# Response to Submissions

100 Bennelong Parkway, Sydney Olympic Park  
SSD 6246

19 November 2014

**Figure 1: Extract from solar access report showing impacts of towers to the west on solar access to the site**

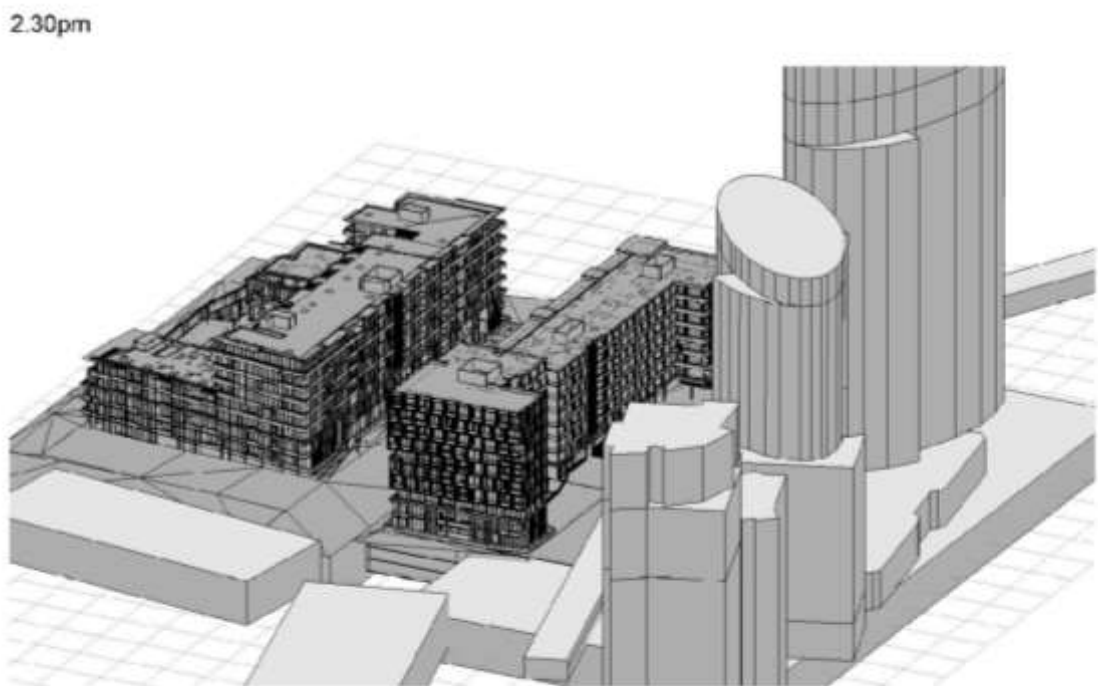
SOPA seeks compliance with the solar access requirements of both the SOPA Masterplan and the 3-hour category of the Residential Flat Design Code.

In order to fully comply with the solar access requirements of the above, the proposal would need 10 more units with 3 hours solar access to comply with the SOPA MP; and 5 more units with 3 hours solar access to comply with SEPP 65/RFDC. However, there are significant factors influencing the ability of the development to fully comply with the solar access requirements of both controls.

The proposal has been designed with the footprints of the buildings to accord with the SOPA Masterplan. Further, solar access to the site is adversely affected from 2.30pm onwards by the existing towers to the west of the site. **Figure 1** below contains an extract from the solar access report. It shows that from 2.30pm onwards, the subject site is affected by the buildings to the west in terms of solar access. The extent of this impact is great enough to prevent full 3-hour compliance, as units on the western side of the development will begin to lose sun from this time of the day onwards.

It is noted that in terms of the SOPA requirements, 86% of the apartments receive at least 2 hours of sunlight; and in terms of SEPP 65/RFDC, 84% of the apartments receive at least 2 hours of sunlight. Despite being short of complying with the 3 hours solar access, the proposed units will exceed the percentage when measured in terms of 2 hours. This indicates that a greater number of apartments would be closer to getting 3 hours solar access than 2 hours solar access.

Under the circumstances of the site and its surroundings, the amended proposal is considered to provide for good solar access to units that will ensure a high level of amenity to residents.
